Project No. 24-09  
CJUSD Central Freezer Facility

**Center Joint Unified School District  
CJUSD Central Freezer Facility @ M&O Yard  
Project No. 24-09  
8408 Watt Avenue, Antelope, CA 95843**

## ADDENDUM NO. 1 - 4/29/2024

SHEET X2

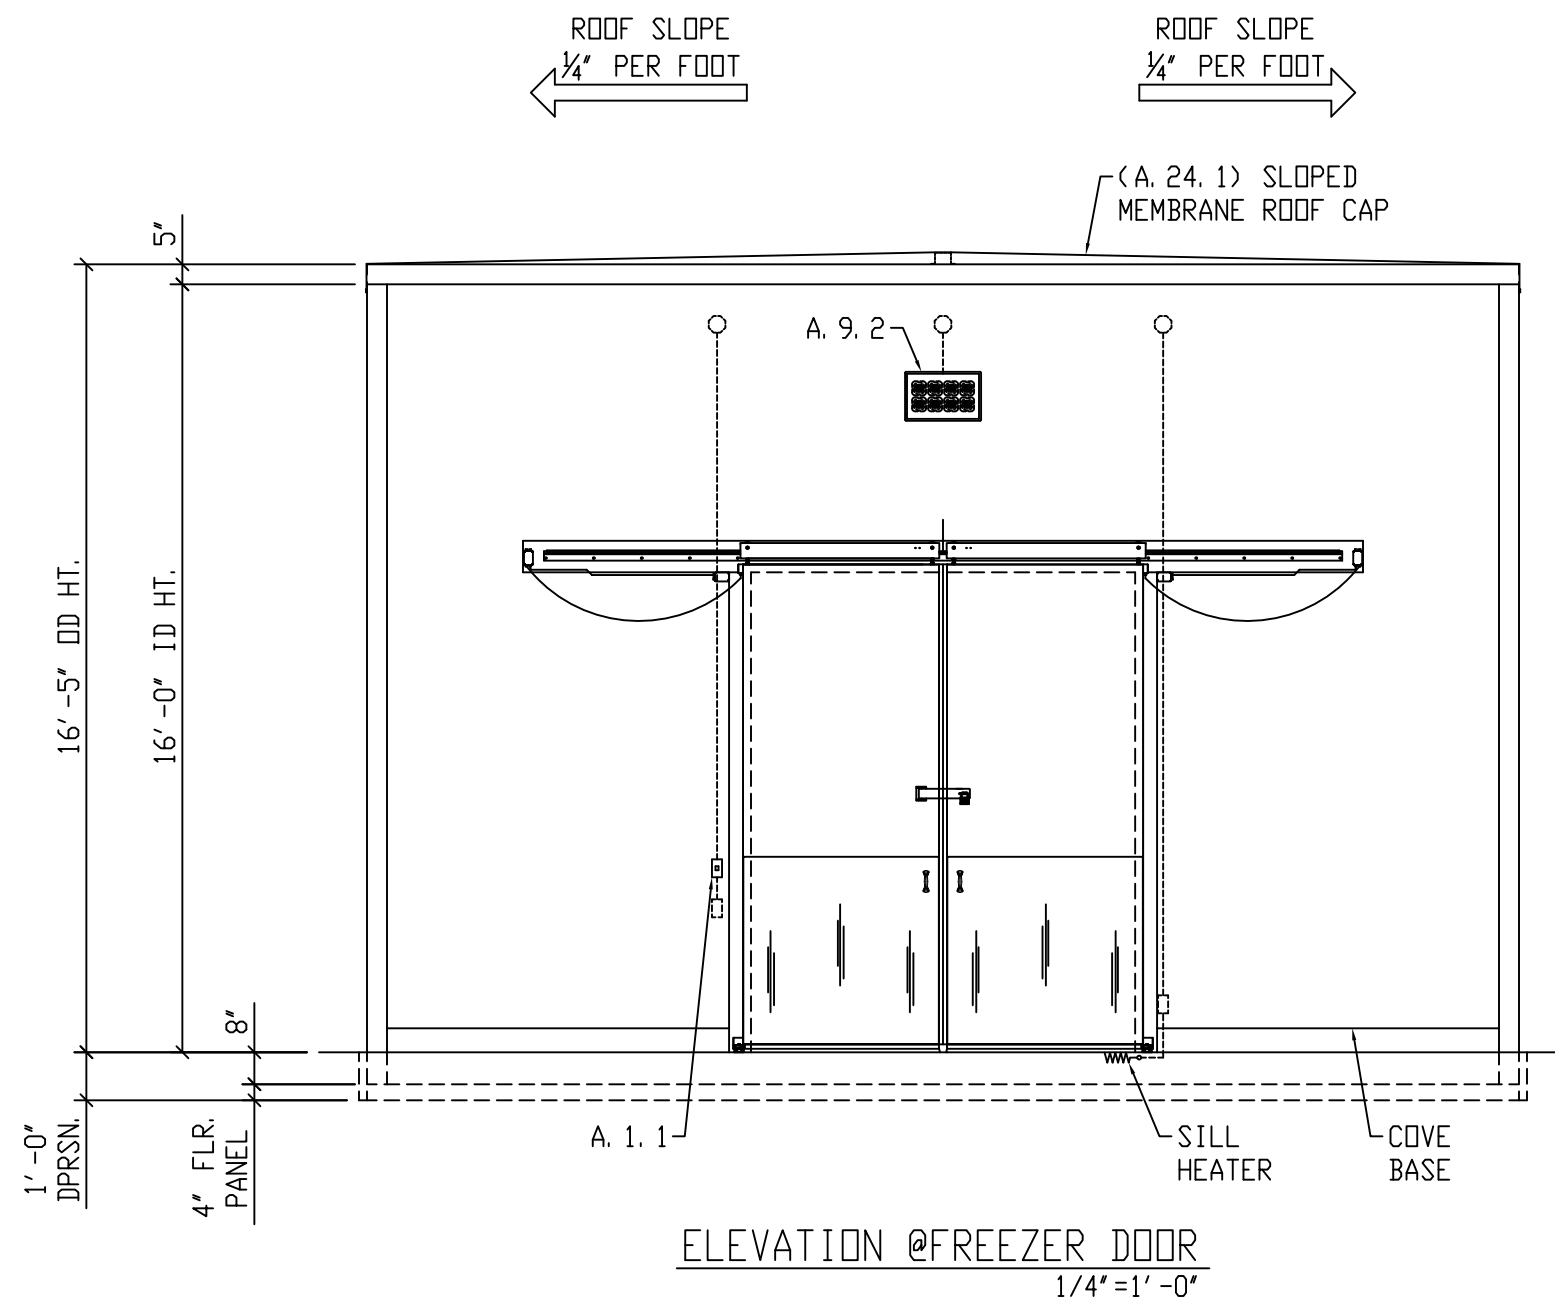
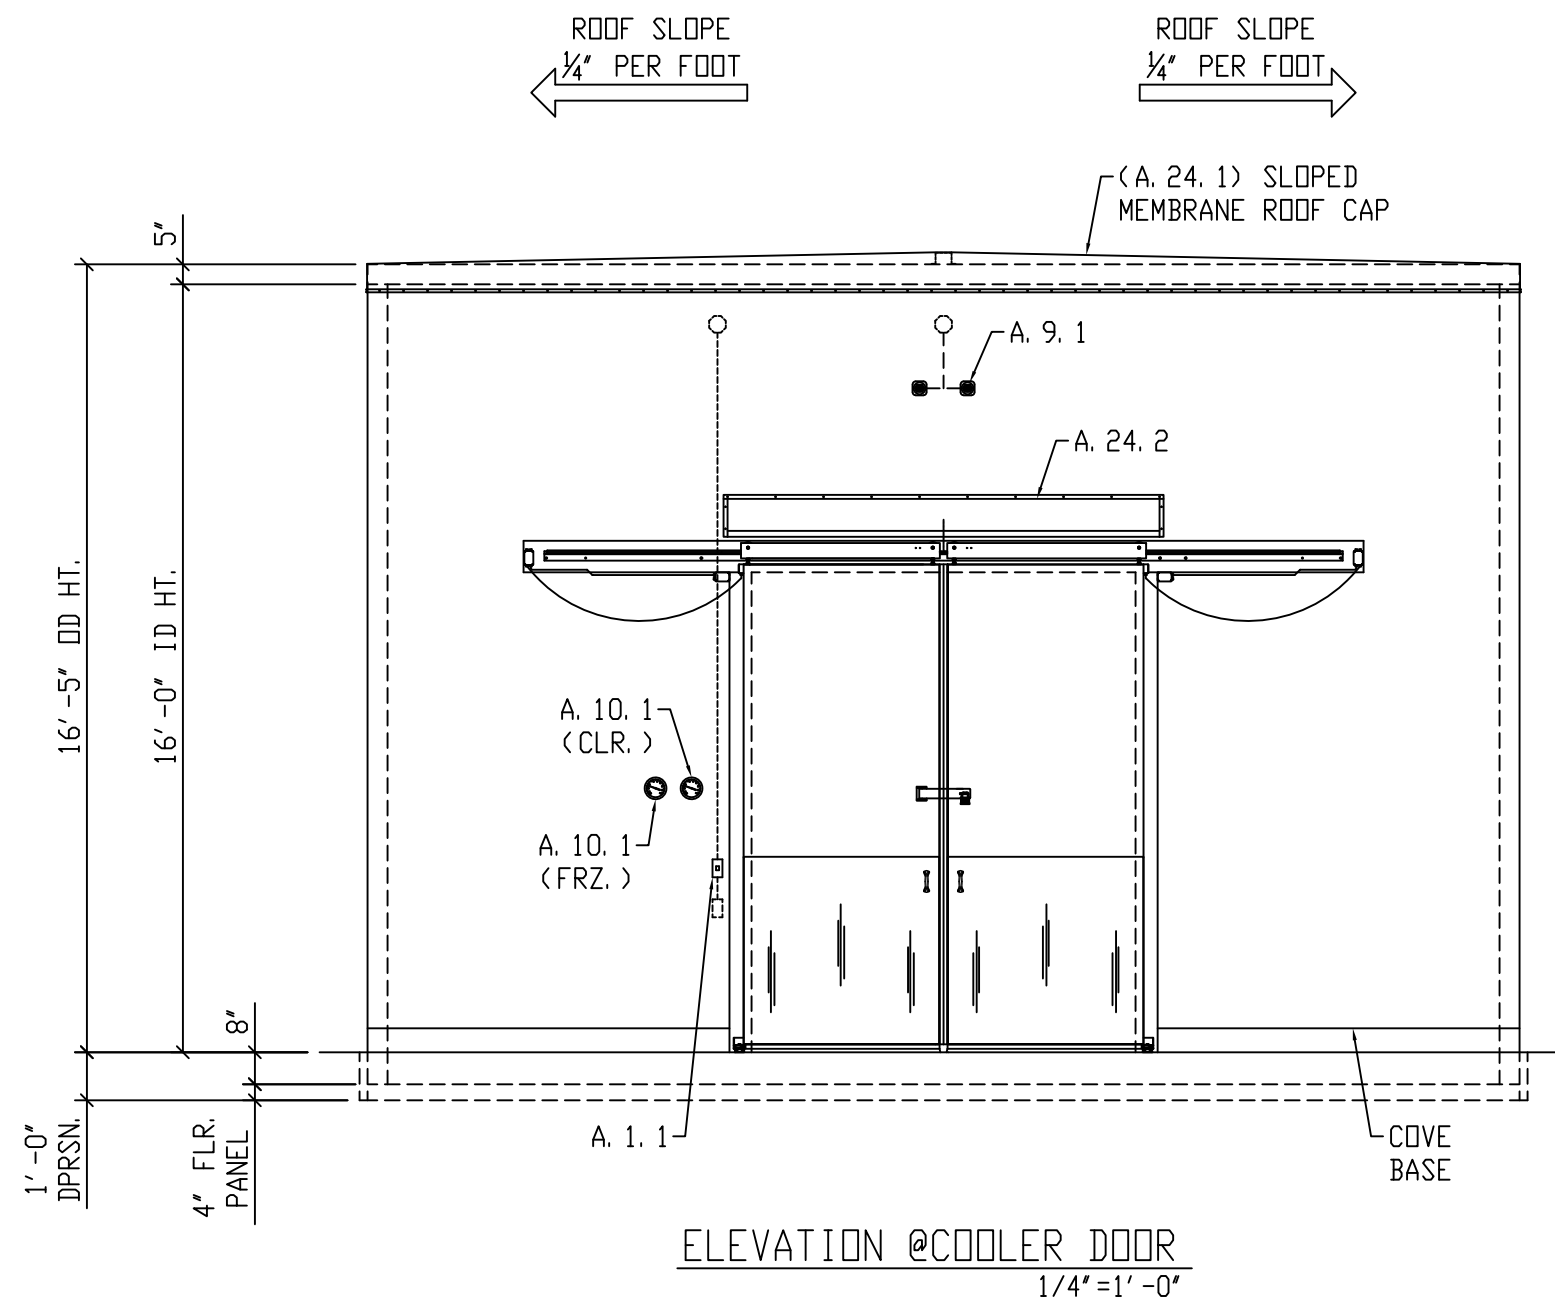
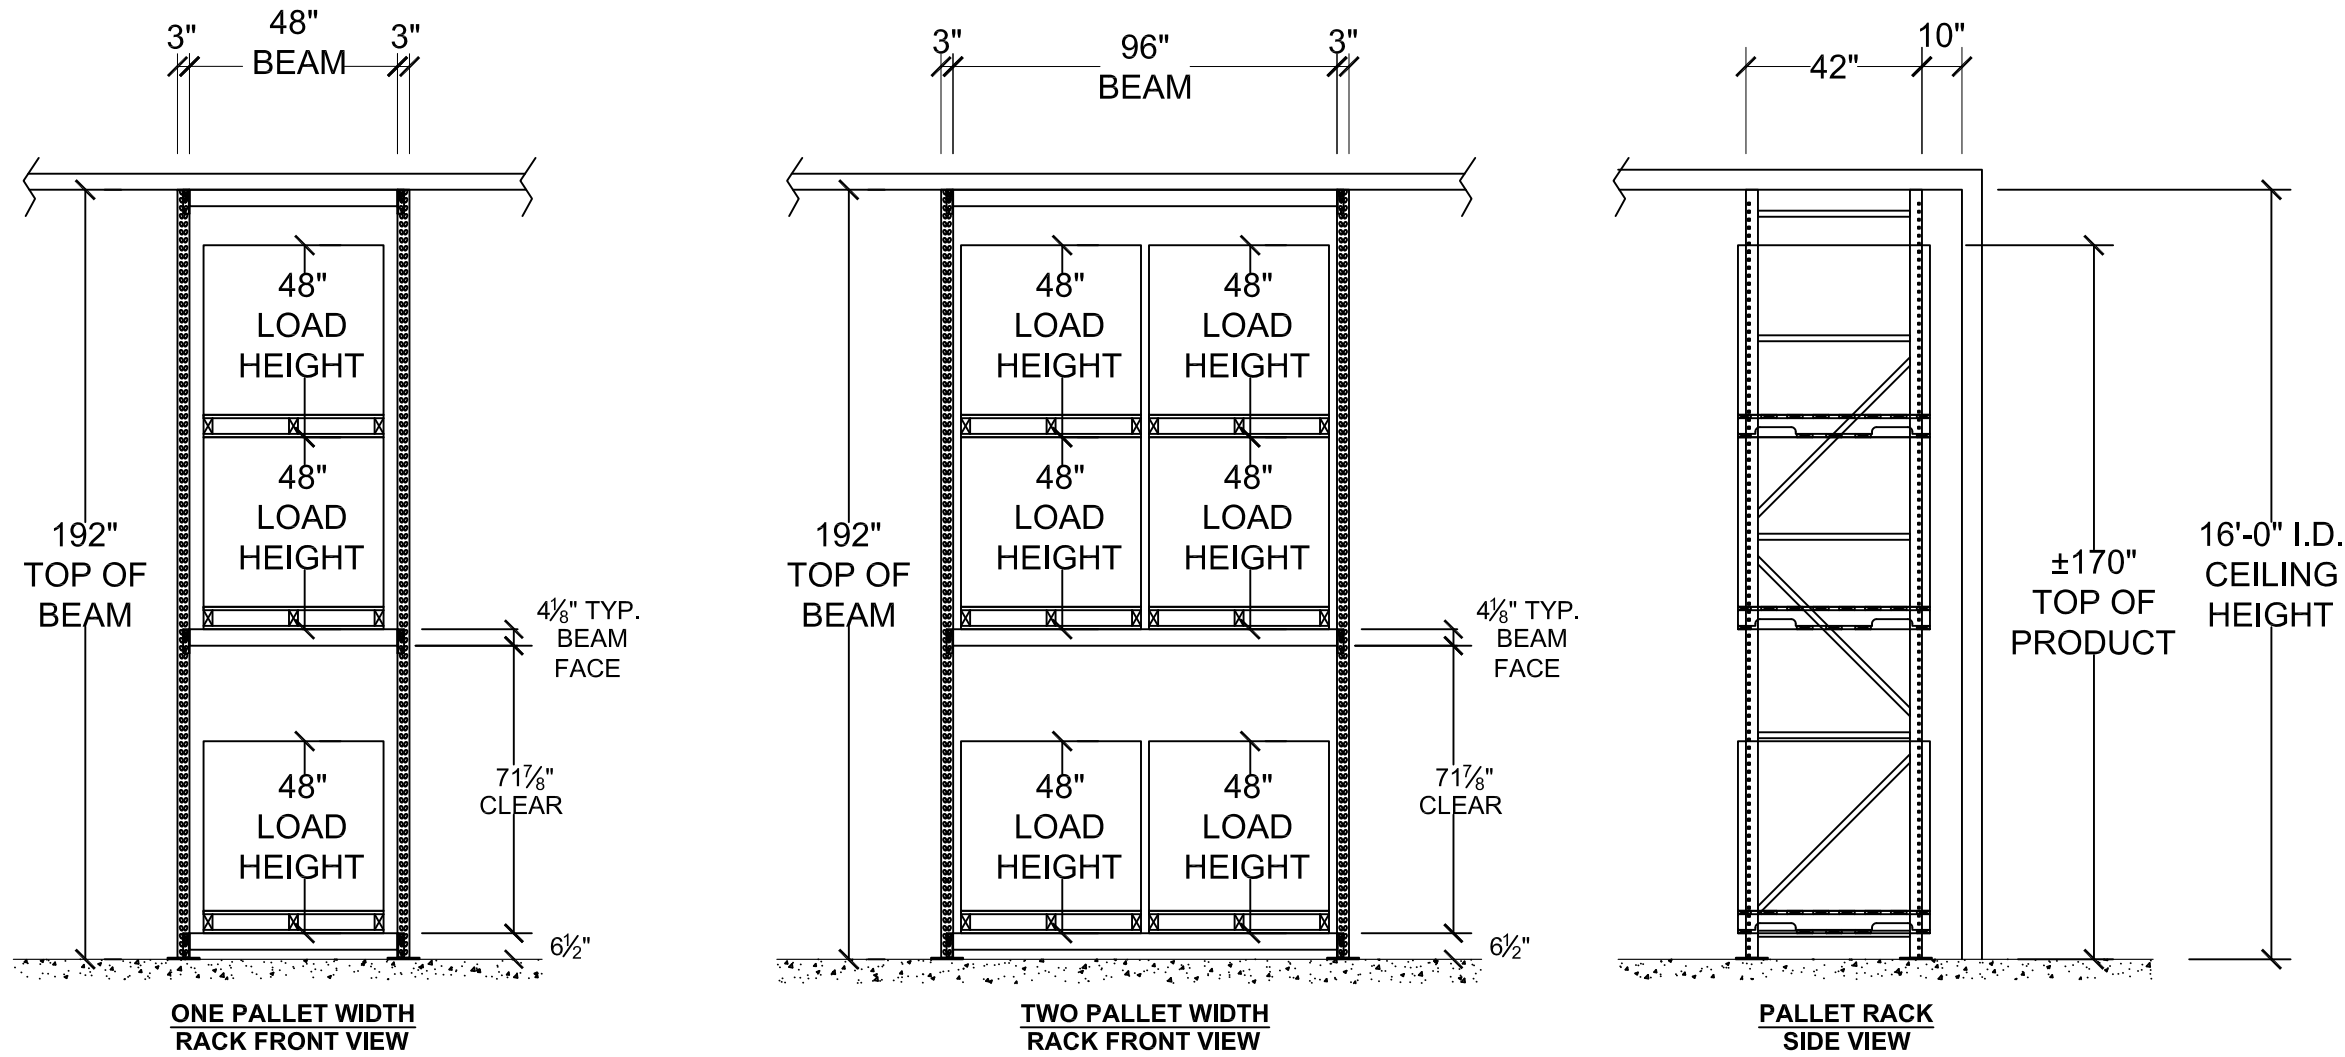
- New sheet added - See attached.
- Note - While this sheet is primarily for reference for RMI/Airdyne provided and installed equipment, some site development work is identified on this sheet.
